UNITED STATES PATENT AND TRADEMARK OFFICE

Office Action Summary	Application No. 10/647,726	Applicant(s) MORELAND ET AL.	
	Examiner Michael P. Ferguson	Art Unit 3679

DETAILED ACTION

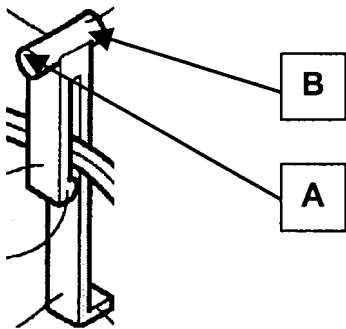
As to claim 17, Moreland discloses a lock wherein, measured along the intersection of the body **82** and a plane passing through the neck **84**, a first side **A** (Figure 2 reprinted below with annotations) of the body adjacent to the neck is wider than an opposing side **B** of the body (Figure 2).

As to claim 26, Moreland discloses a system wherein, measured along the intersection of the body **82** and a plane passing through the neck **84**, a first side **A** of the body adjacent to the neck is wider than an opposing side **B** of the body (Figure 2).
